VARGA TRAFFIC PLANNING Pty Ltd

8 April 2020 Ref 19084

## DA 2019.91 Proposed Mixed Use Multi Residential Development 28-34 Victoria Street, Burwood Traffic, Parking & RMS Matters

BASEMENT 04

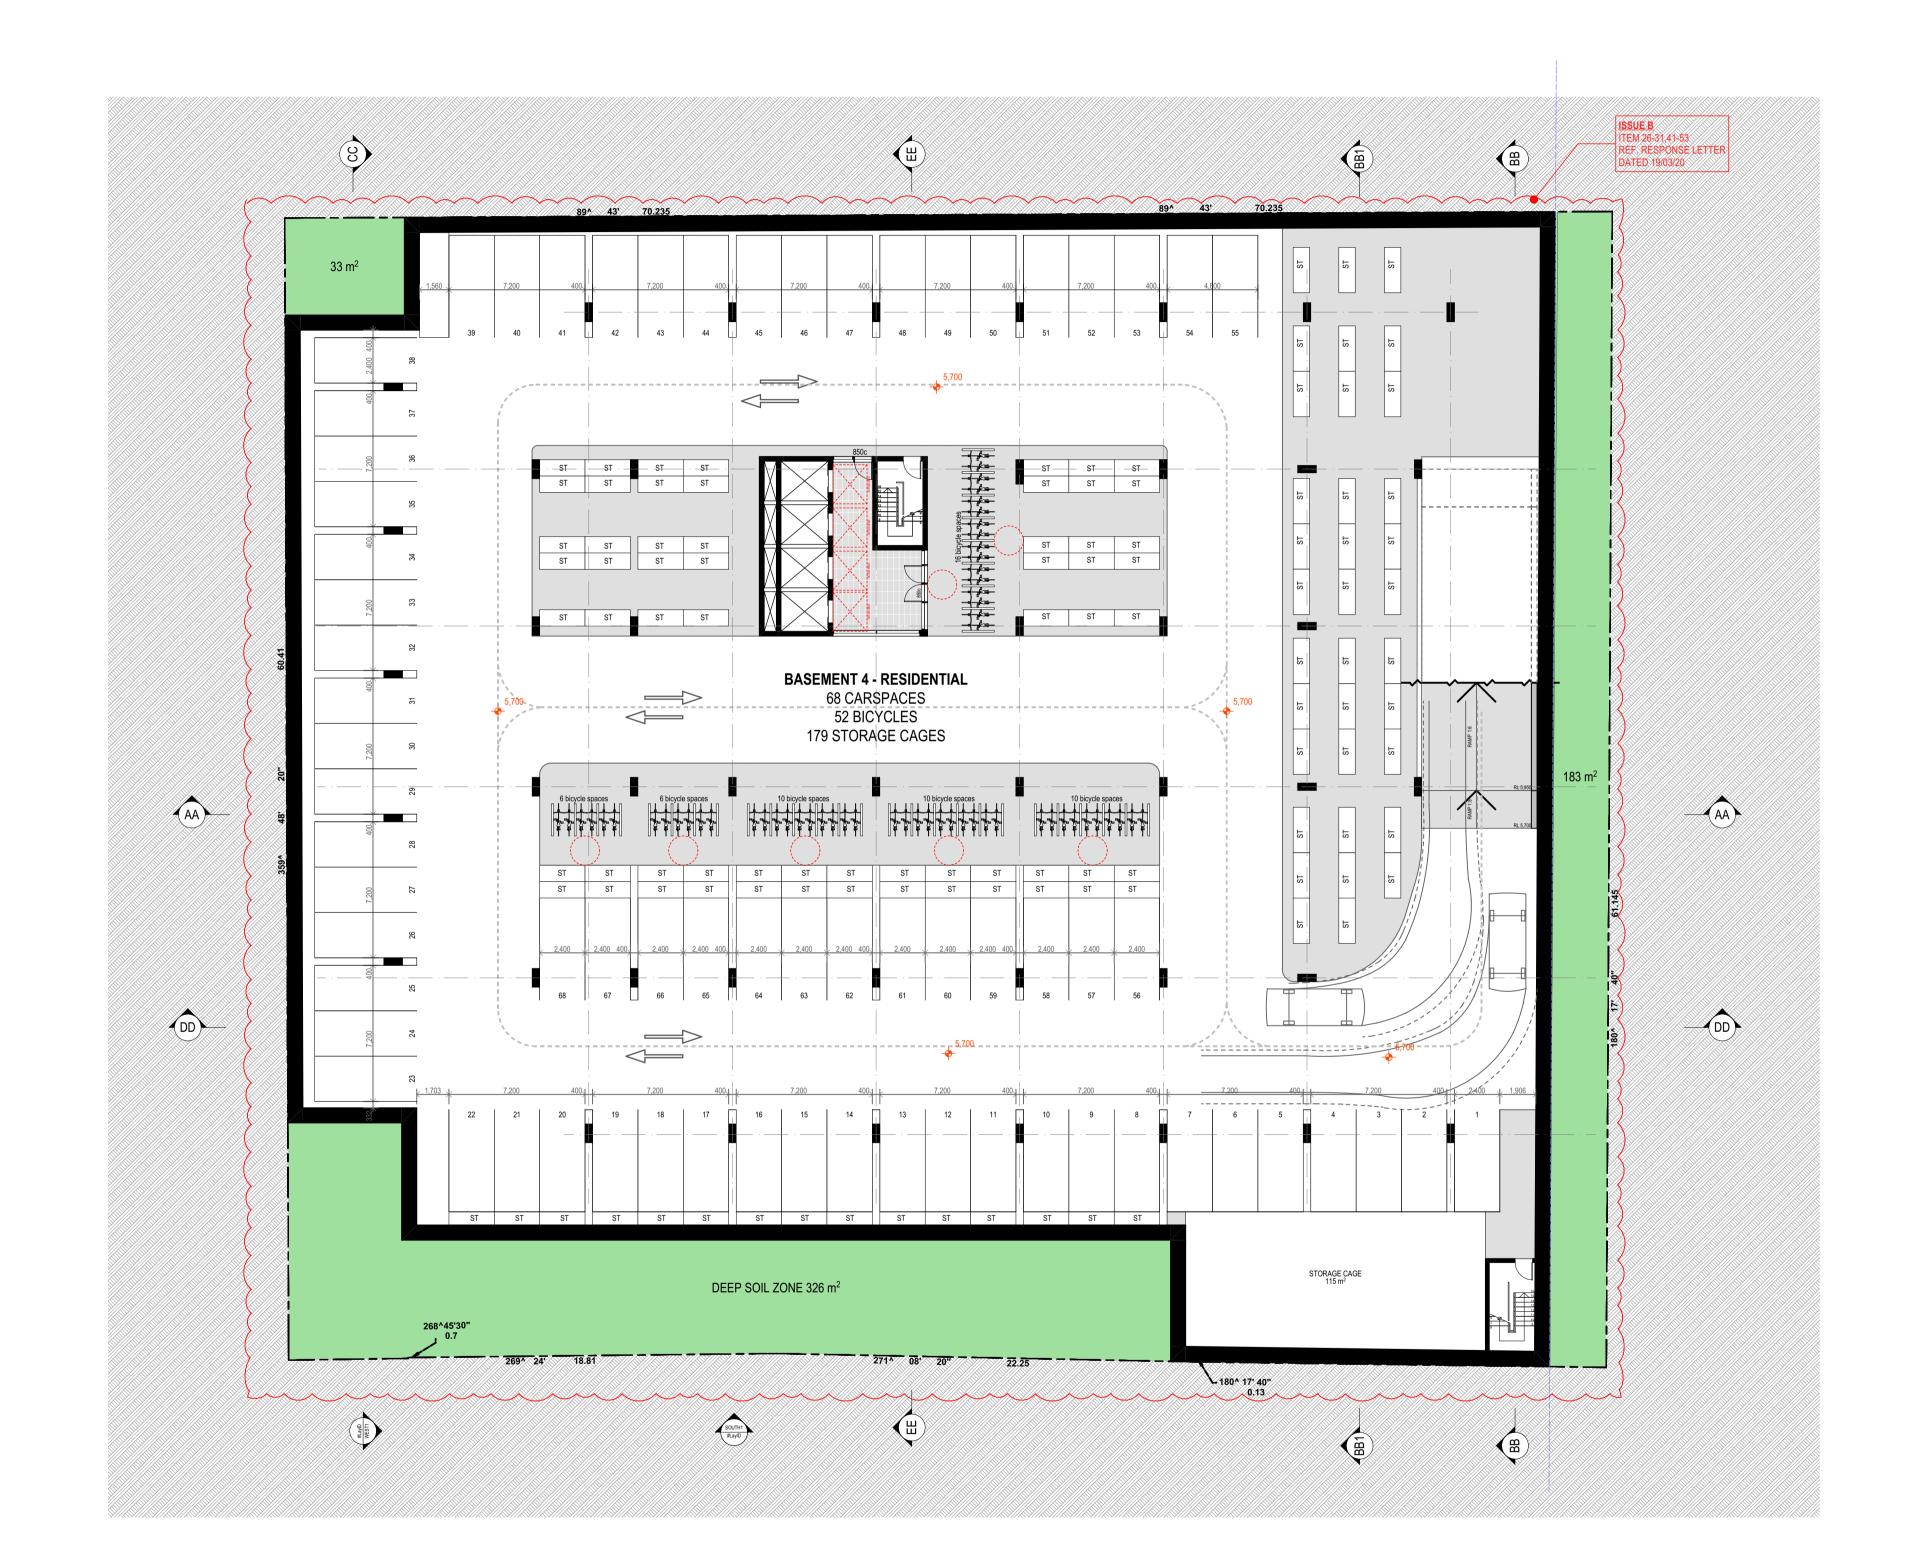
Item 1 - an additional level of basement is now proposed which therefore satisfies the car parking shortfall based on the parking rates specified in Council's *DCP*.

Item 2 – the additional level of basement also includes bicycle parking which now satisfies the bicycle parking shortfall.

BASEMENT 02 SCALE 1:200

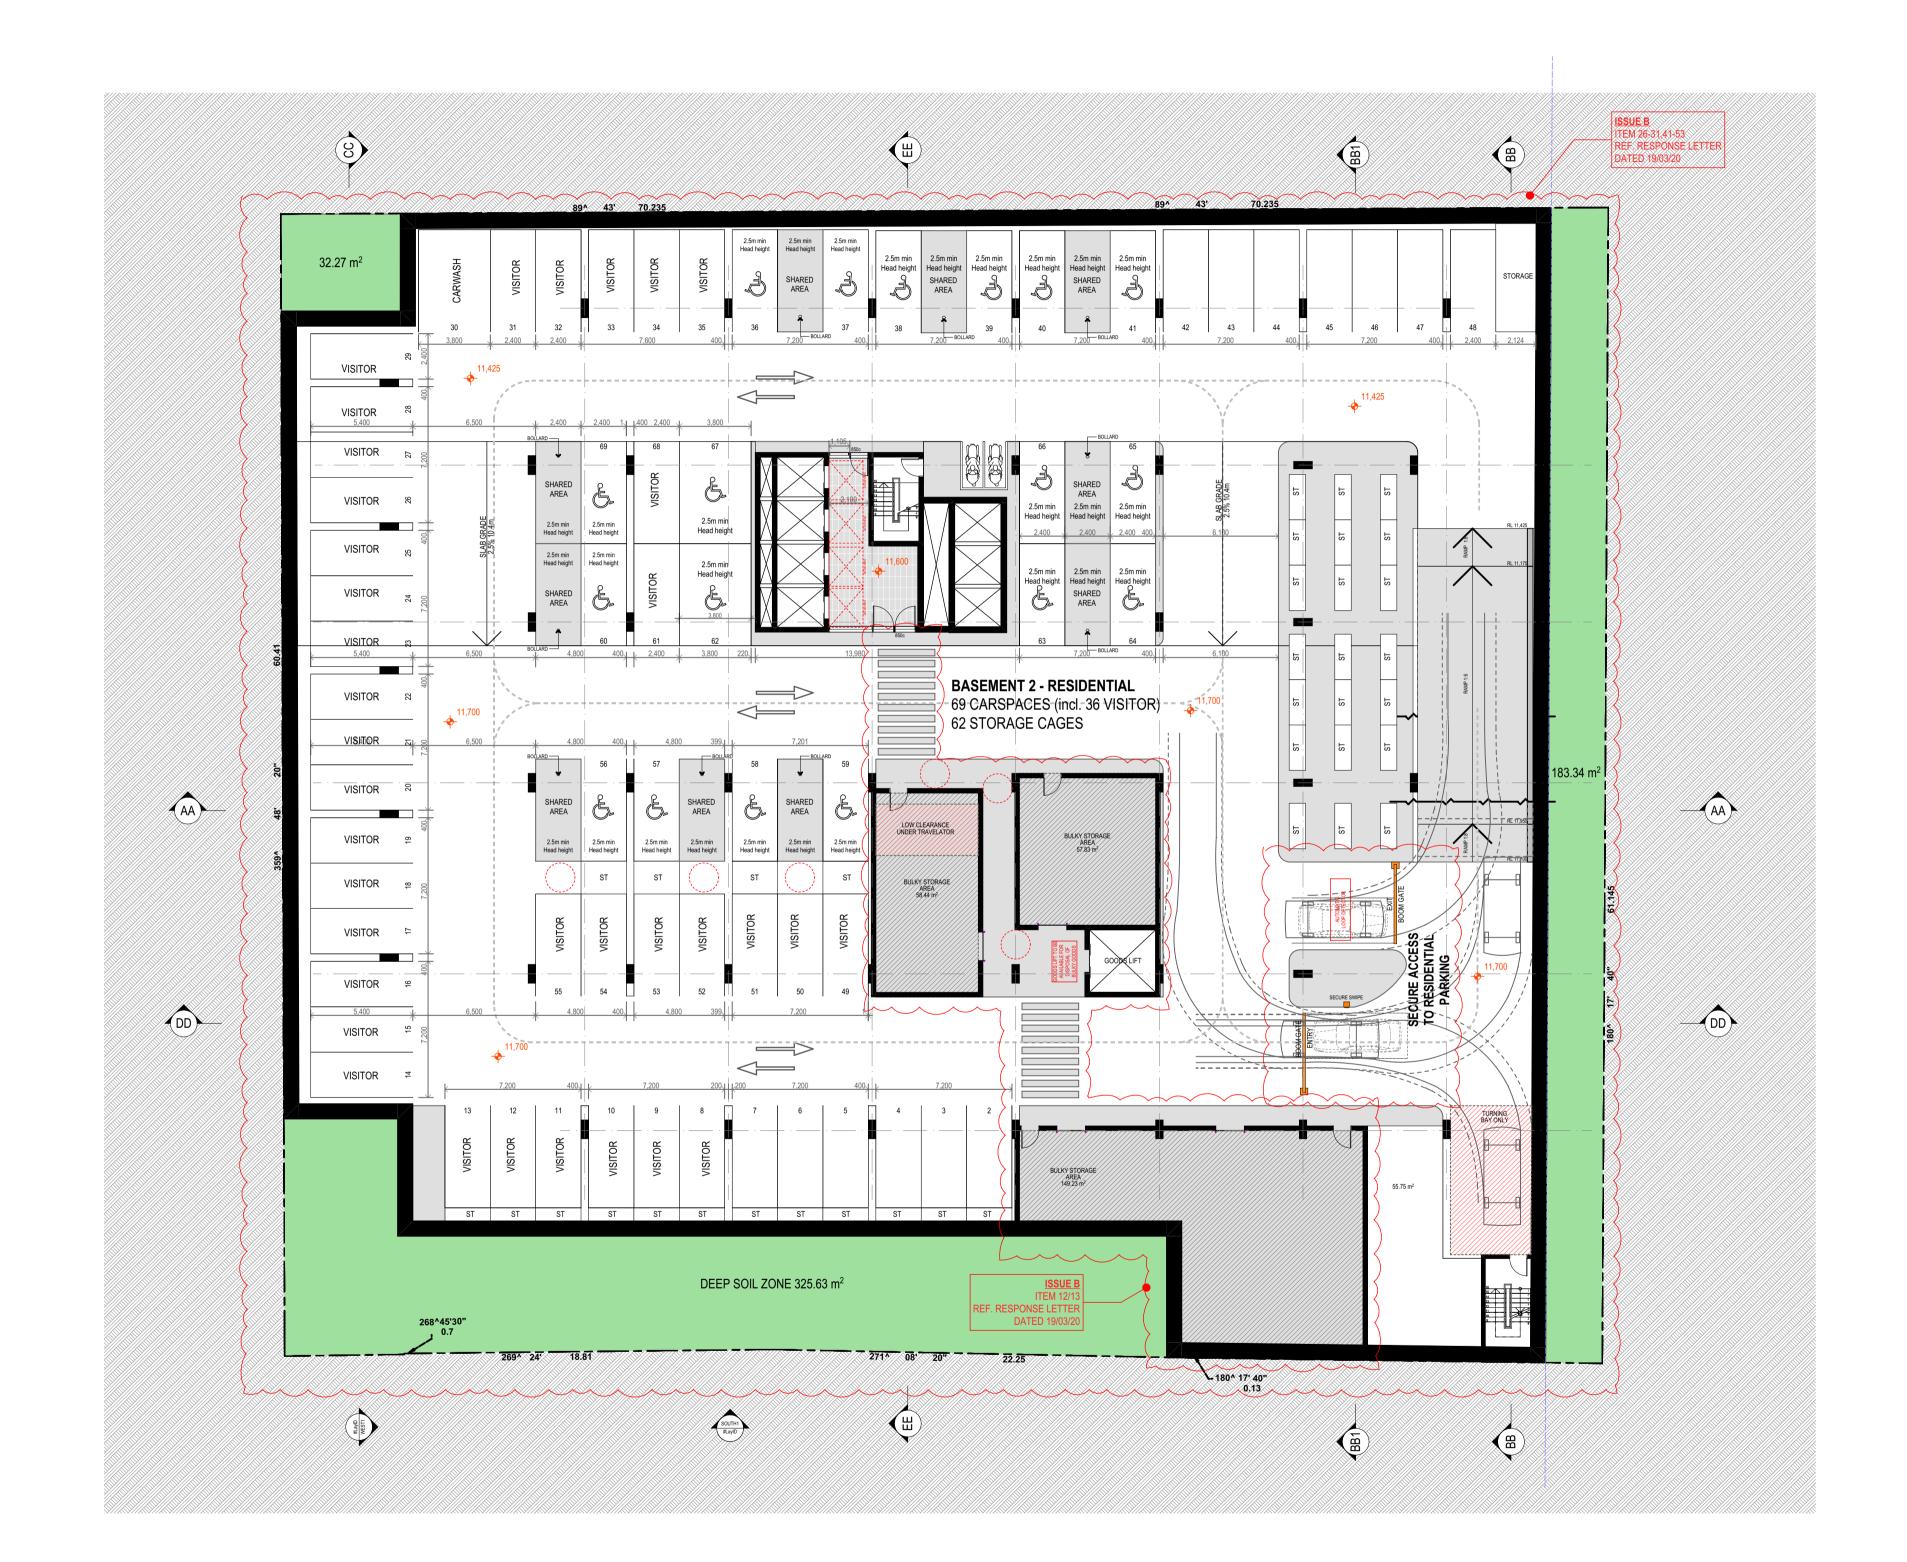
Item 9 - the area in front of the boom gates which provides access to the residential parking area on B2 has been amended and now includes a reverse bay in the event a visitor cannot gain access through the boom gates. Furthermore, and as noted above, the non-residential parking area now includes a circulation system which is a superior design to the original layout as it does not require turn/reverse bays in the event a dead-end aisle is fully occupied.

Item 10 – the access point into the residential parking area has been relocated to the bottom of the B1-B2 ramp, including the intercom and boom gates. Sufficient manoeuvring/queuing area is now provided which will not impede parking spaces on B1.

BASEMENT 01 SCALE 1:200

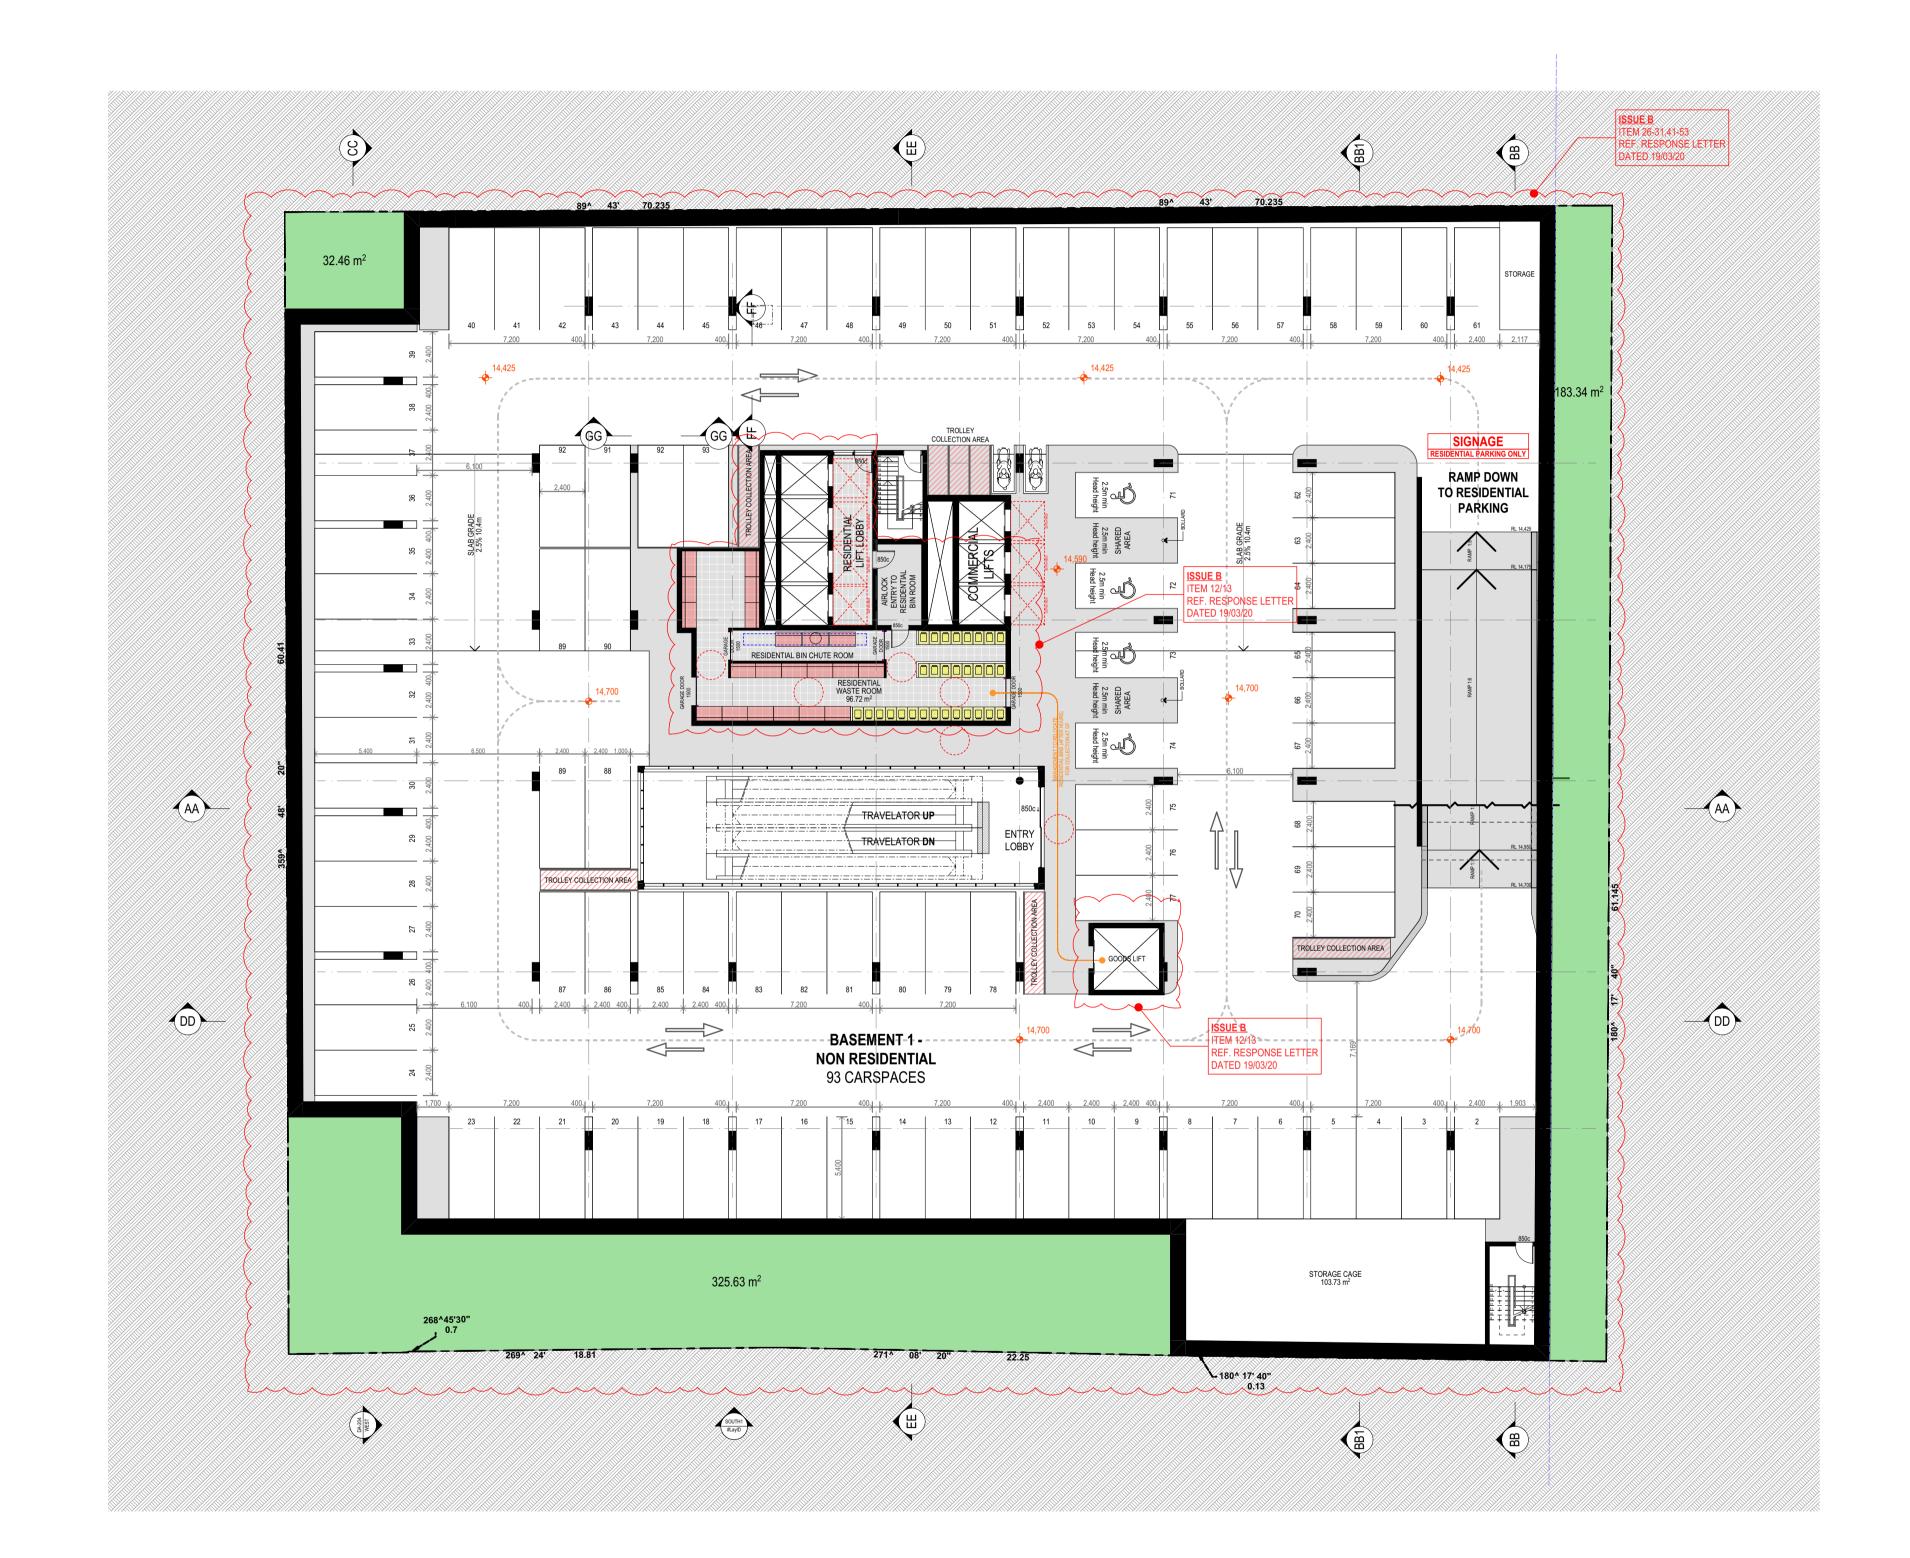
Item 4 – the internal intersection of the loading dock access and top of the basement access ramp has been amended in order to provide increased visibility and manoeuvring area, particularly for the trucks. Furthermore, the intersection will also be suitably linemarked and signposted, giving priority to car traffic accessing the basement parking area.

Item 5 – the loading dock has been redesigned and now caters for an 11m long rigid truck *and* a 6.4m long SRV truck. Both trucks are able to enter/exit their respective loading bay *independently* of the other. A Loading Dock Management Plan (LDMP) was prepared by *Road Delay Solutions* and submitted with the original DA submission. The LDMP includes all relevant information, including but not limited to, operating hours, procedures, expected truck sizes and frequencies.

Item 6 – the non-residential parking area on B1 has been amended and now includes *minimum* 6100mm wide circulation aisles. In addition, the non-residential parking area now includes a circulation system which is a superior design to the original layout as it does not require turn/reverse bays in the event a dead-end aisle is fully occupied.
